February 24, 2016

Following recent discussions about Brick North, below is a summary of site work required for Brick North before Certificates of Occupancy can be issued. The attached color-shaded plans delineate site plan improvements for Brick North. Completion of this work will be considered towards fulfillment of the Level III Site Plan approval The Forefront at Thompson's Point Amendment Phase 1A, PEZ.2014-120 (approved December 4, 2014). This summary applies exclusively to requirements for Brick North. Full execution of the recently approved Level III Site Plan and Subdivision approval, PEZ.2015-133 & 2015-159 (approved January 21, 2106), is required for occupancy of Brick South.

PROJECT  
BRICK NORTH AND SOUTH BUILDINGS AT THE FOREFRONT AT THOMPSON'S POINT  
SHEET TITLE  
SITE LAYOUT PLAN  
CLIENT  
FOREFRONT PARTNERS | LP

FST  
FAY, SPOFFORD & THORNDIKE  
ENGINEERS - PLANNERS - SCIENTISTS  
778 MAIN ST, SUITE 8, SOUTH PORTLAND, ME 04106  
DRAWN: DED  
DESIGNED: BEK  
CHECKED: SRB  
FILE NAME: 2982.05-B3 SITE LAYOUT  
DATE: APRIL 2015  
SCALE: 1" = 40'  
JOB NO. 2982.05  
SHEET C-3.0

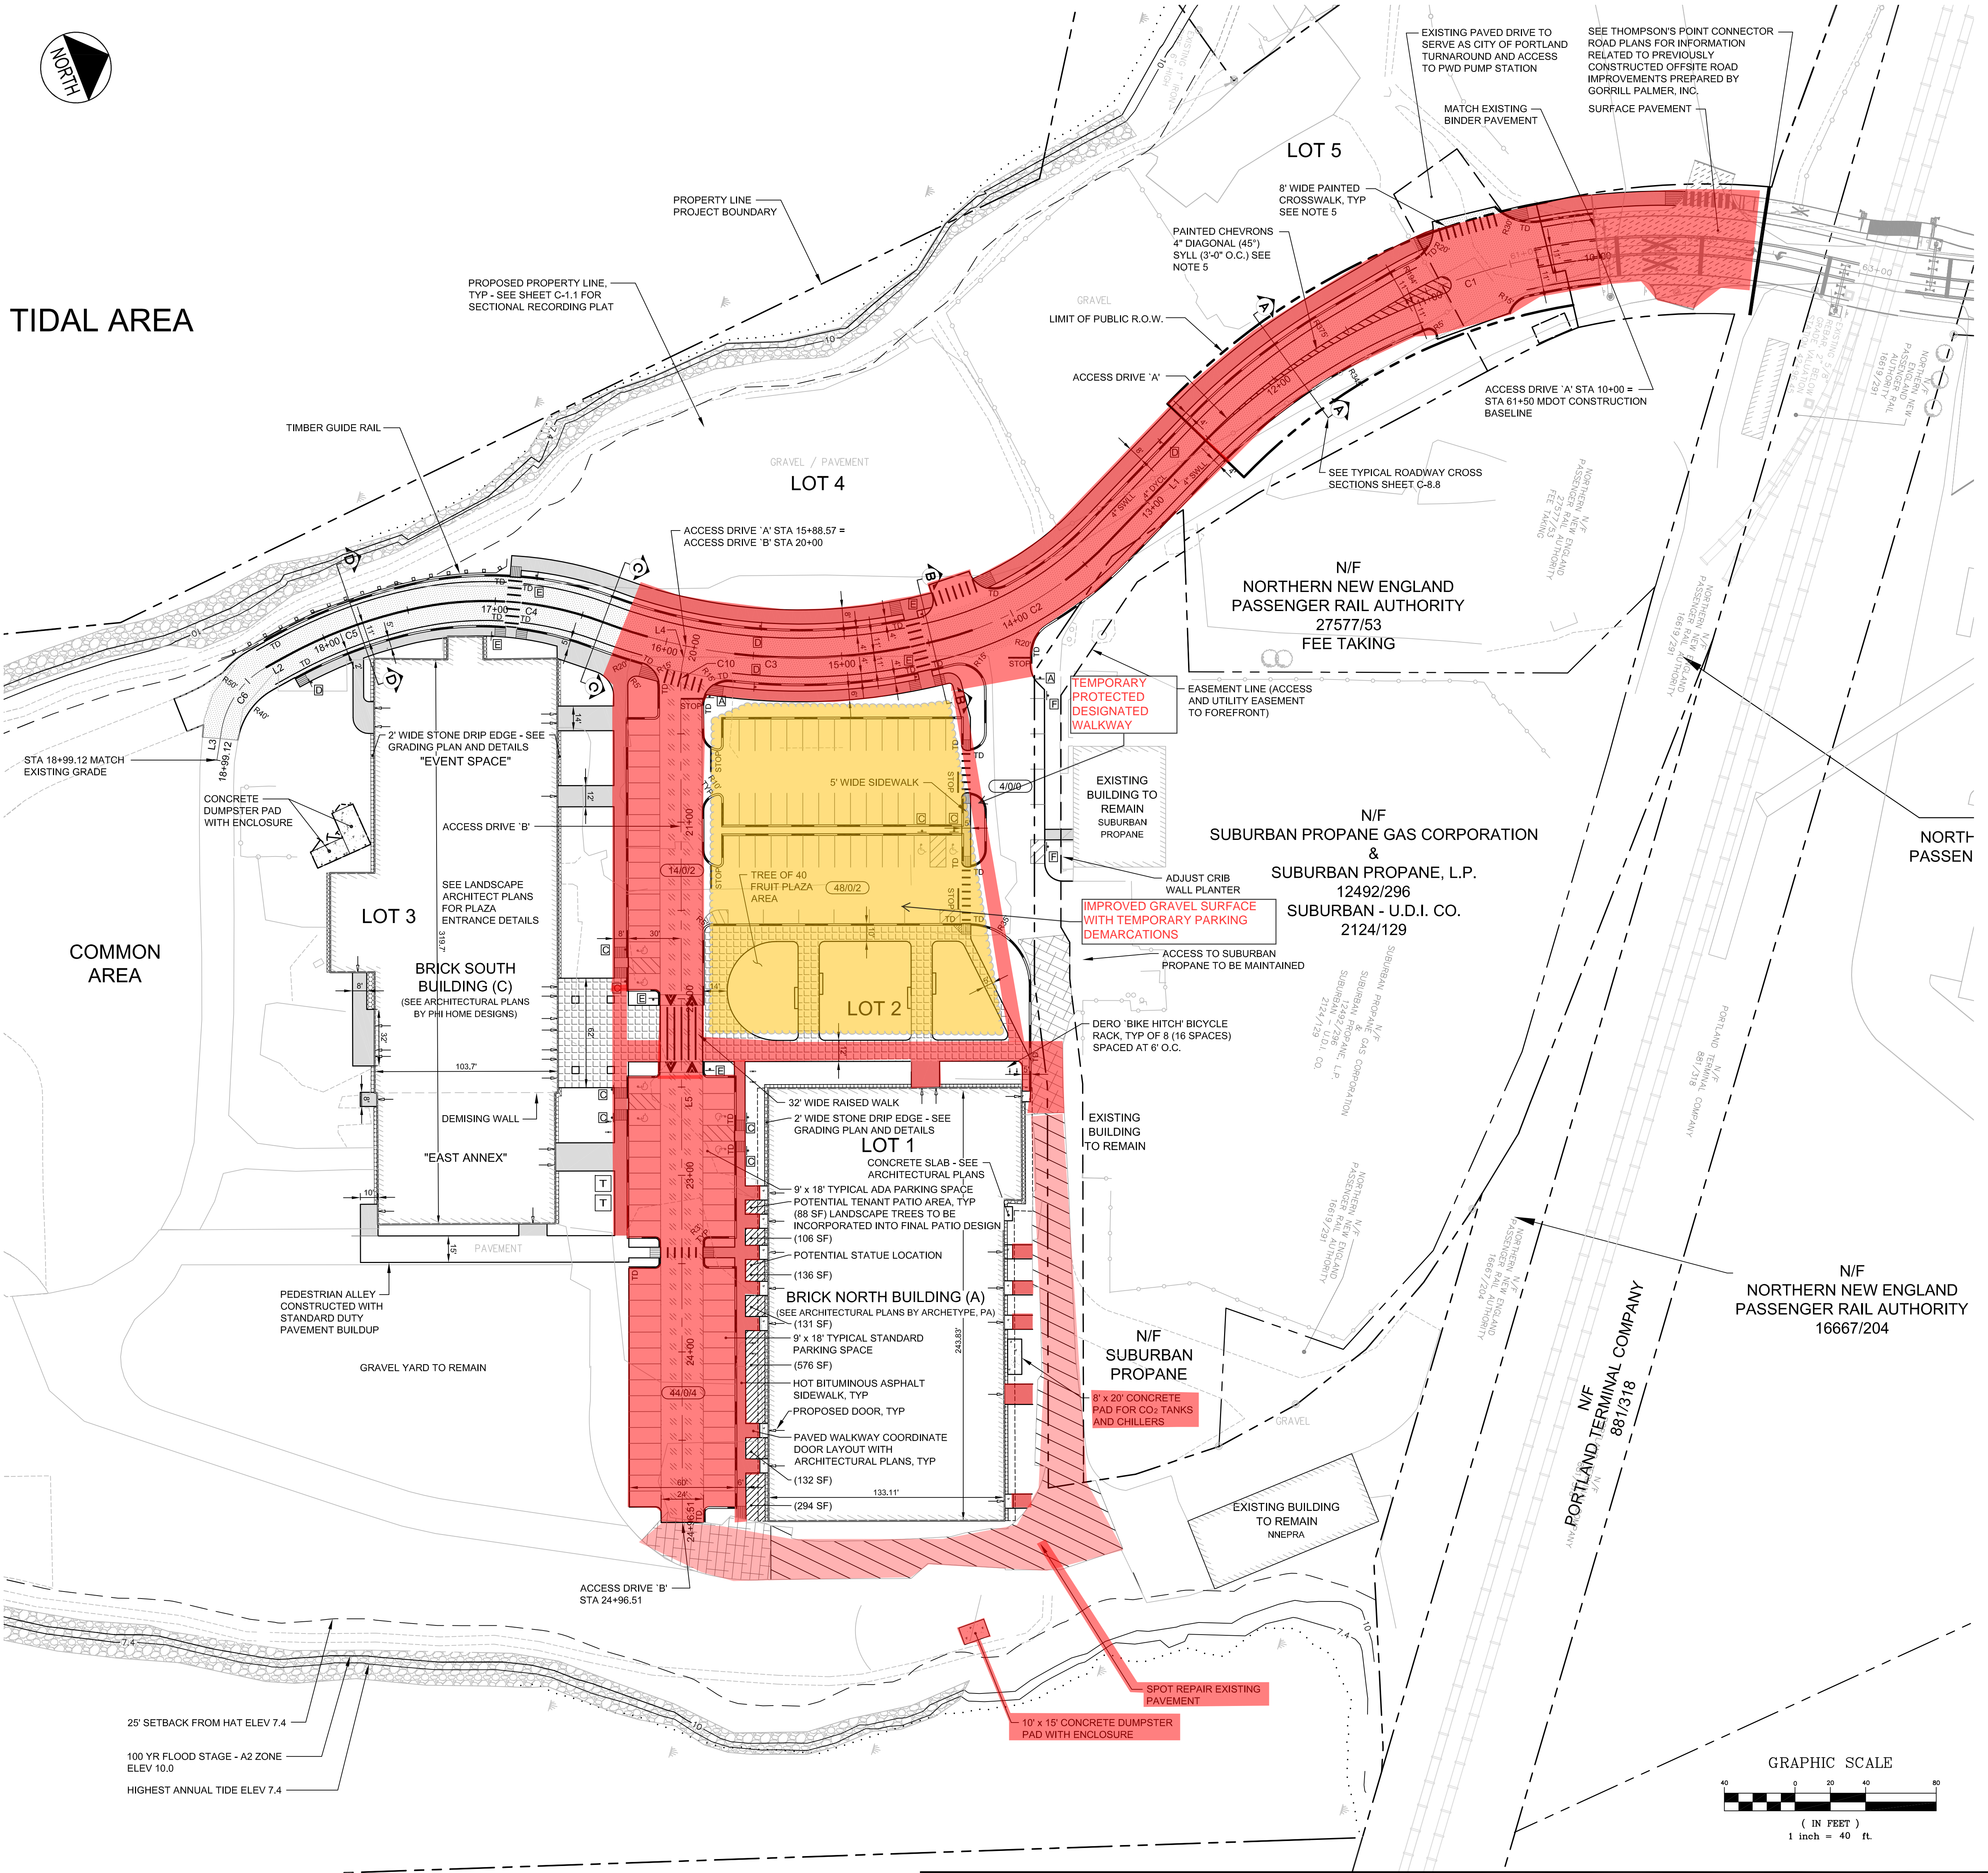
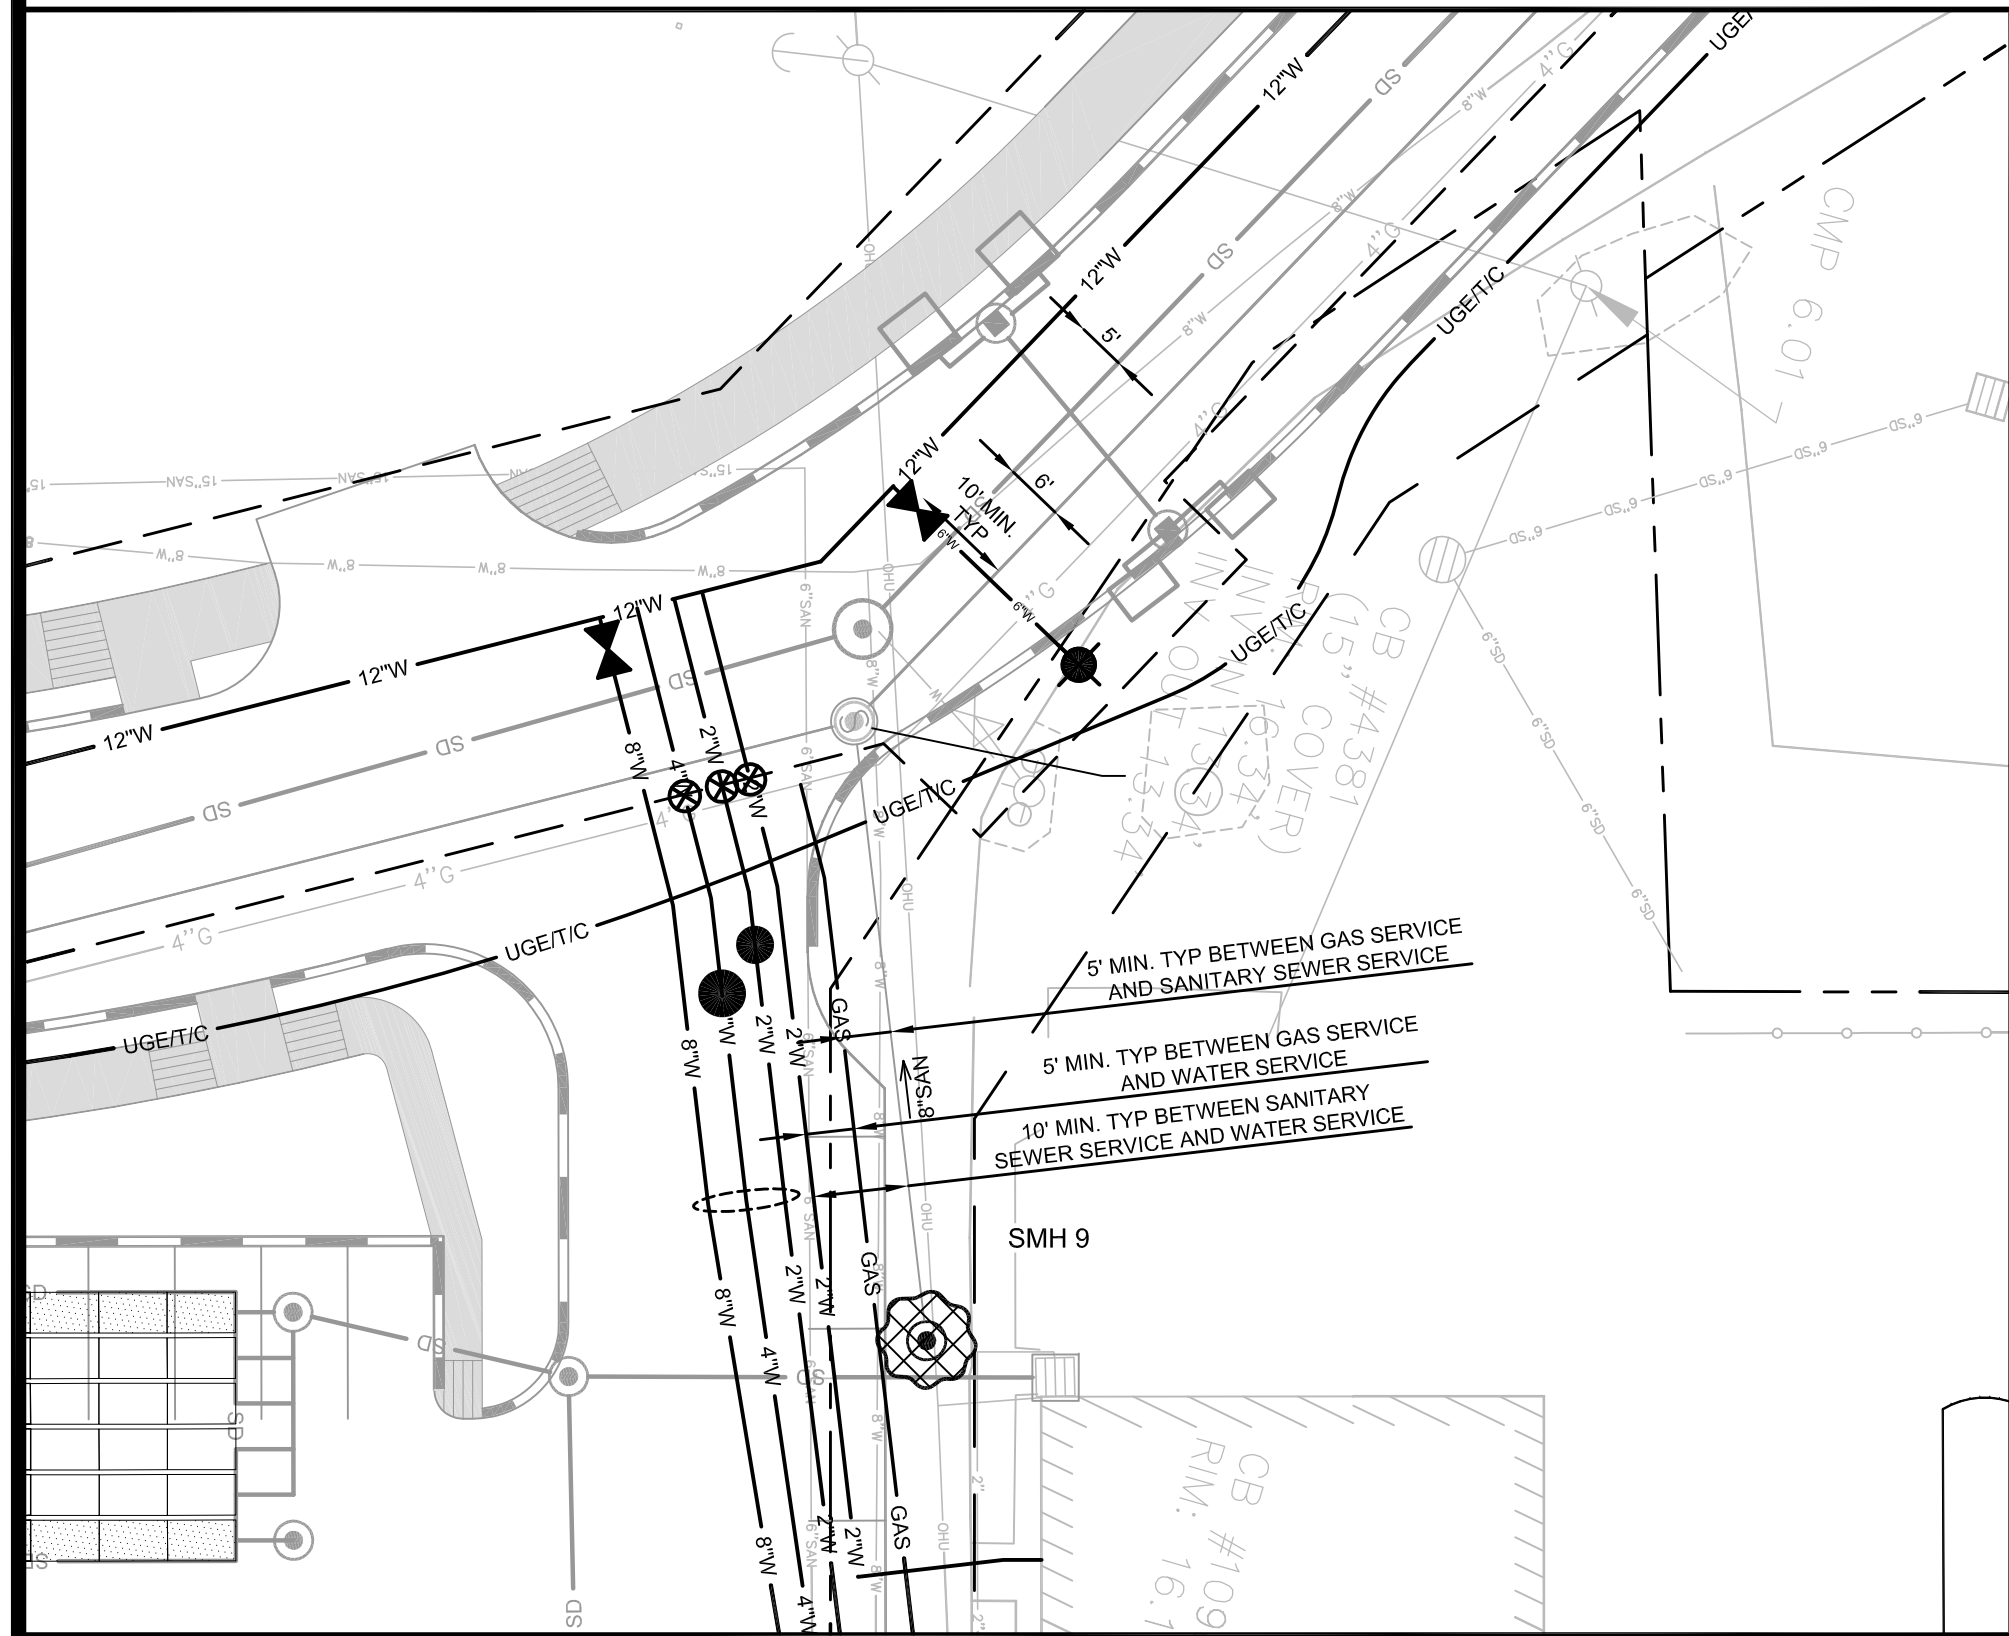
In regard to the areas called out with the notes: *Temporary Protected Designated Walkway* and *Improved Gravel Surface with Temporary Parking Demarcations* on the attached Sheet C-3.0, Site Layout Plan, final details shall be approved by the Planning Authority.
